**NAC INTERNATIONAL**

**REQUEST FOR ADDITIONAL INFORMATION**

**NAC UNIVERSAL TRANSPORT SYSTEM (NAC-UMS)**

**(TAC. No. L22452, DOCKET No. 71-9270)**

Figure 2.51-15 Corner Drop Unfiltered Acceleration Data

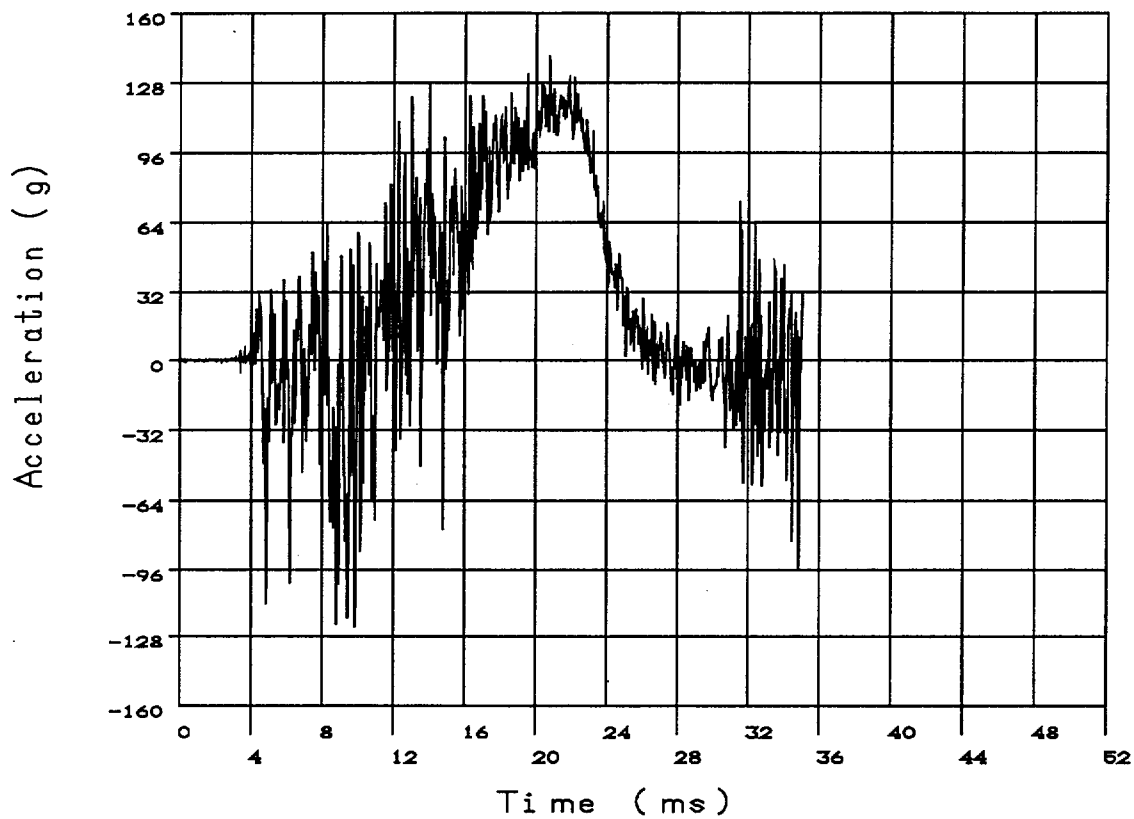
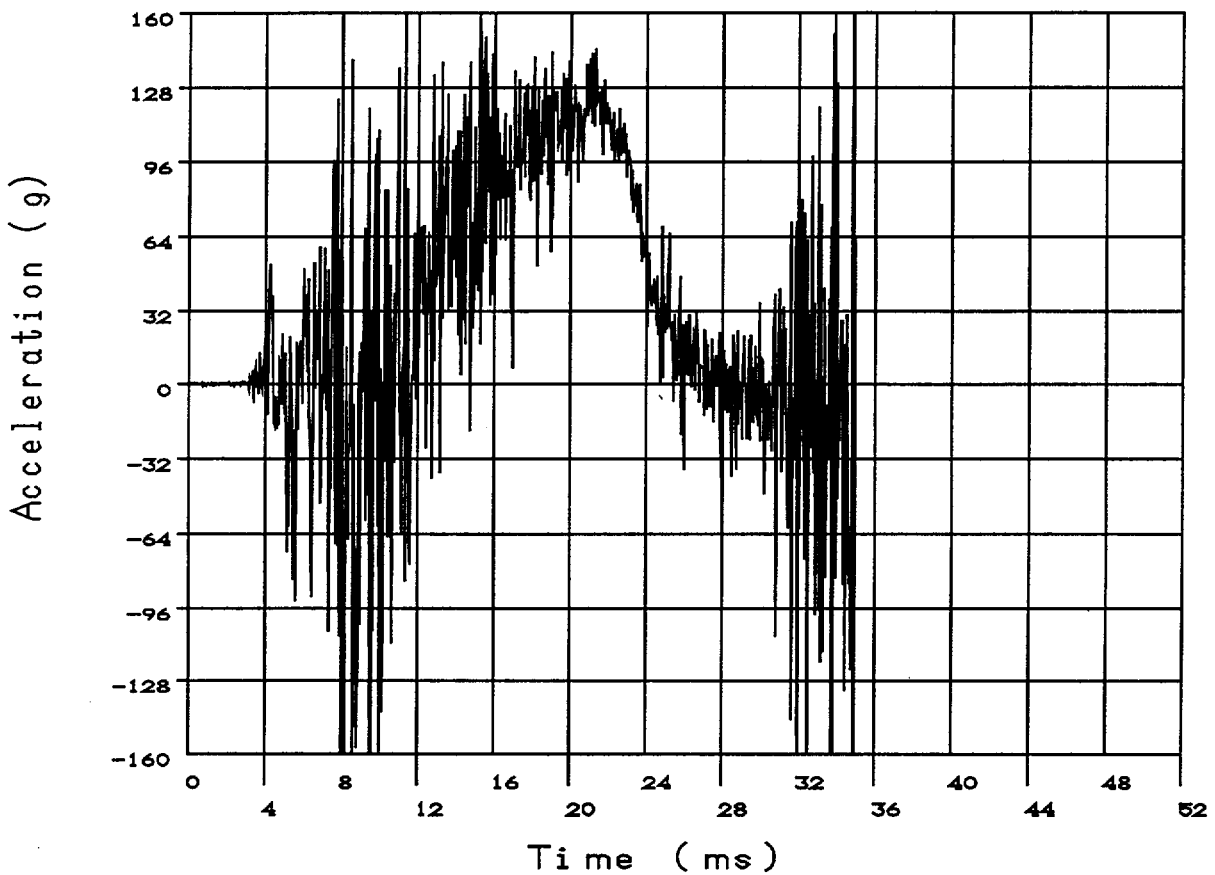
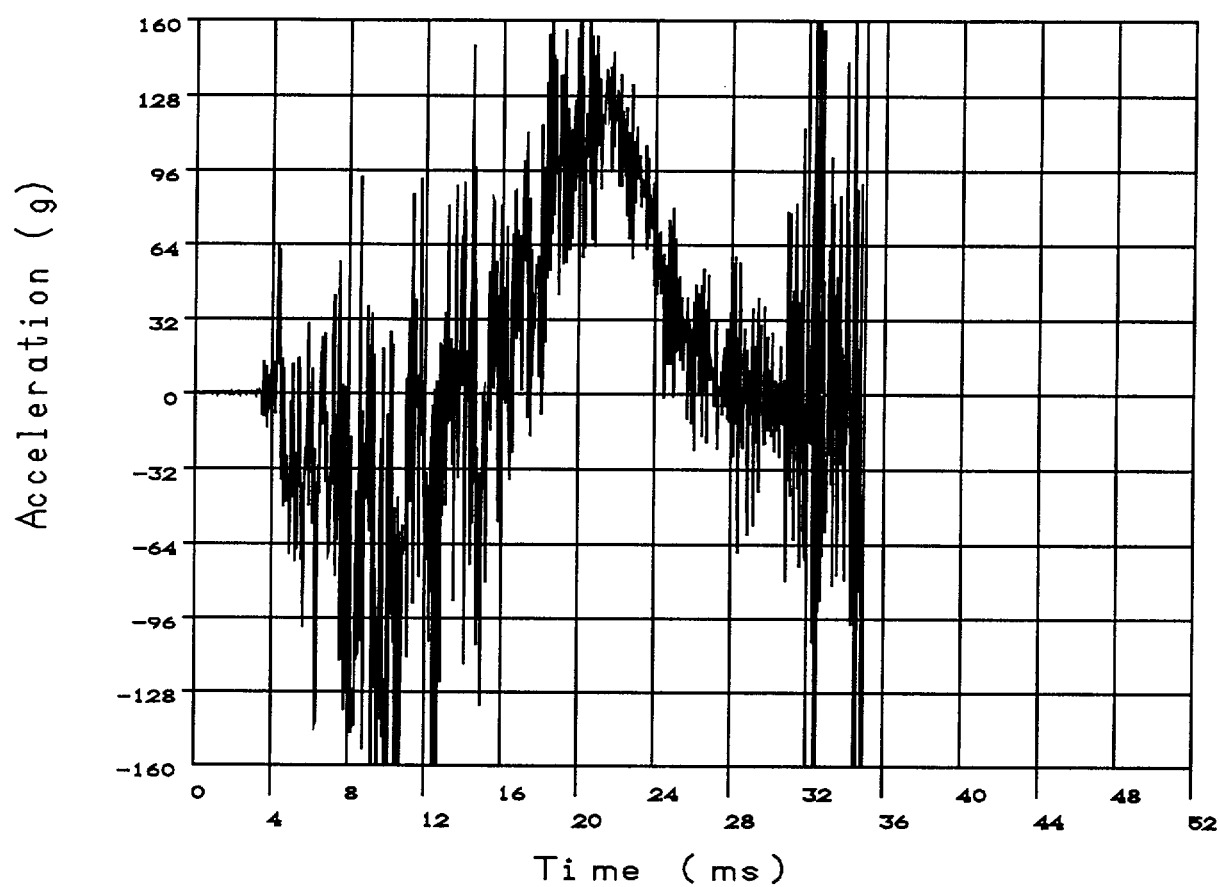
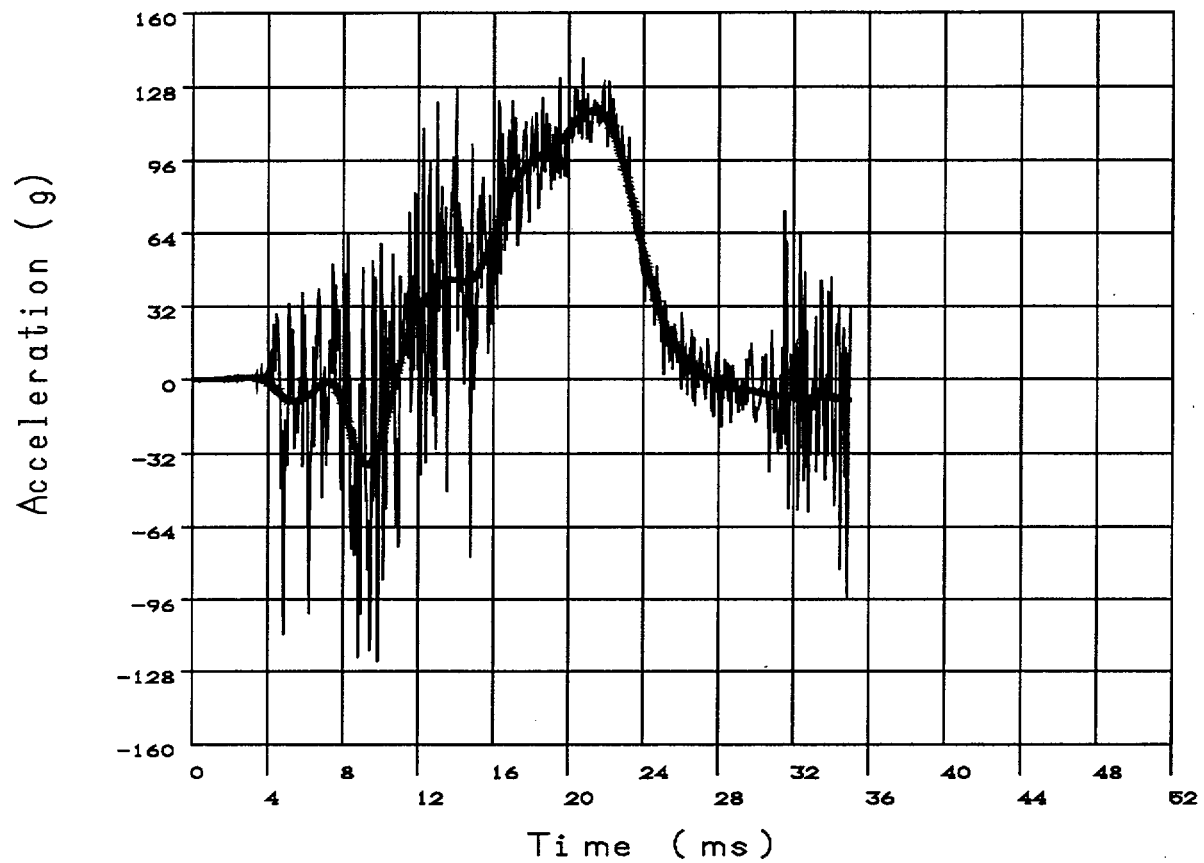
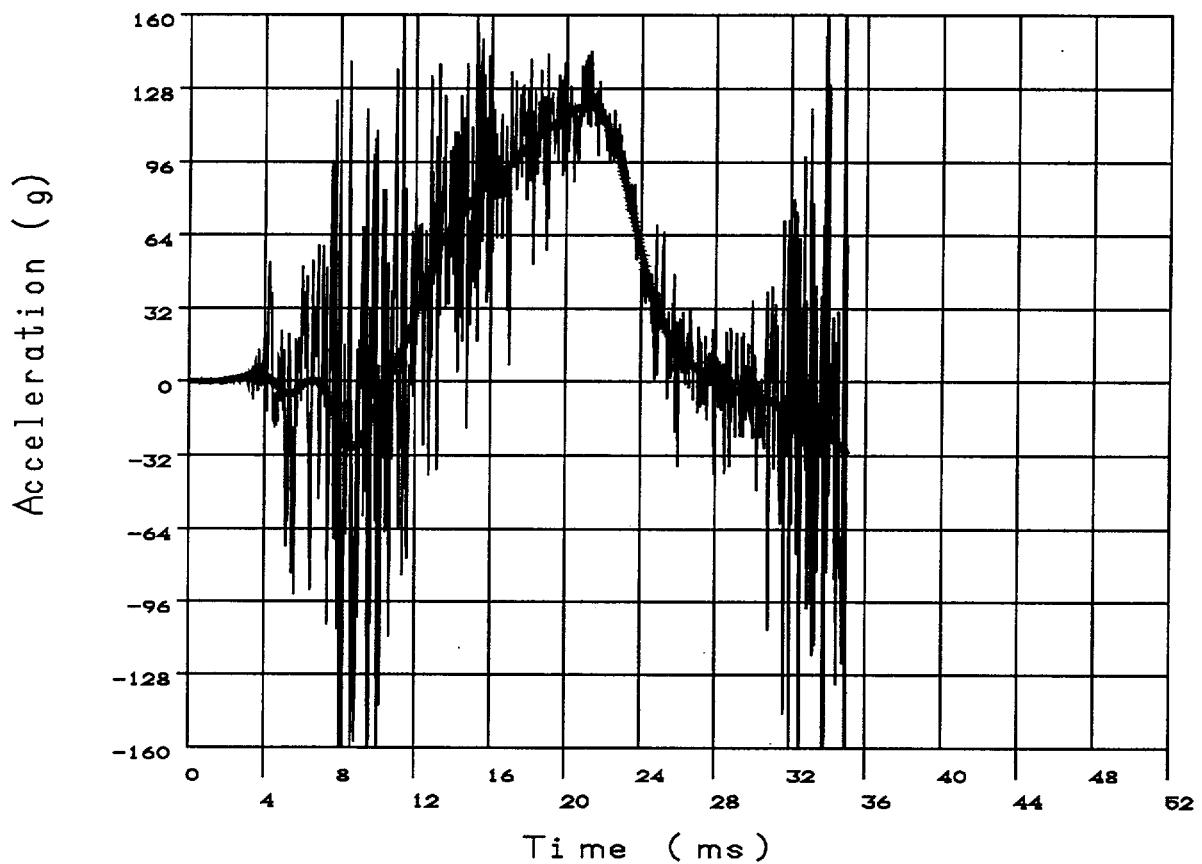
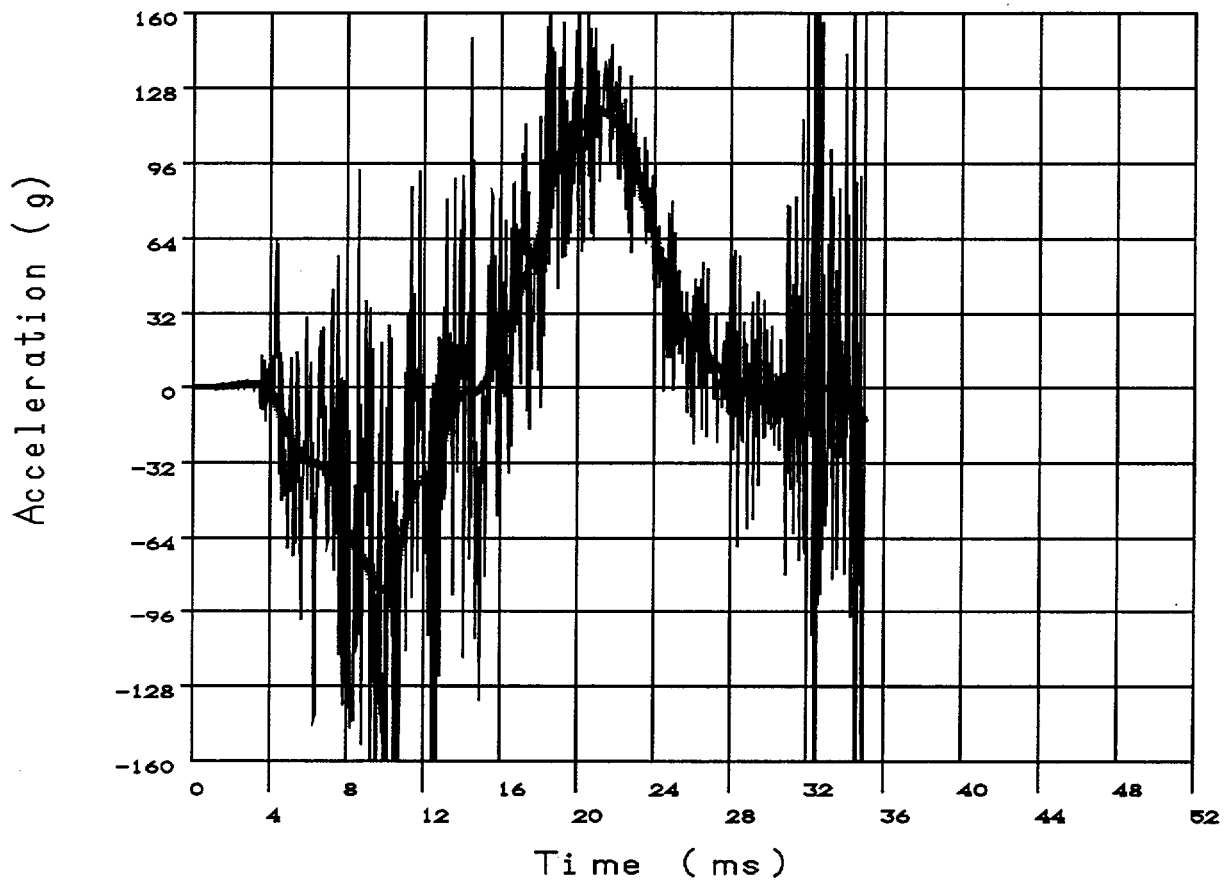
1.        The 1/4-scale cask model should also provide proper simulation of the cask mass moment inertia, in addition to the mass and its center of gravity. The use of weight disks at only the cask top end may not be representative.
2.        The measured acceleration time history in Figure 2.10.3-6 suggests significant cask rocking, which is uncharacteristic of a Universal Transport Cask undergoing side-drop response.
3.        The end-drop acceleration time history in Figure 2.10.3-1 appears to contain much more spurious components than the similar time history for the 1/4-scale drop test conducted for the NAC-STC.

The filtered and unfiltered acceleration time history traces for the 30-foot end and side drop events are provided in Figures 2.51-1 through 2.51-19 of this response. Acceleration data from the three accelerometers used in the 30-foot end drop test and the four accelerometers used in the 30-foot side drop test are presented in the following figures. The filtered data is superimposed on the unfiltered data. The corresponding energy data curves are also provided. The 30-foot corner drop unfiltered and filtered acceleration data are provided in Figures 2.51-15 through 2.51-20.
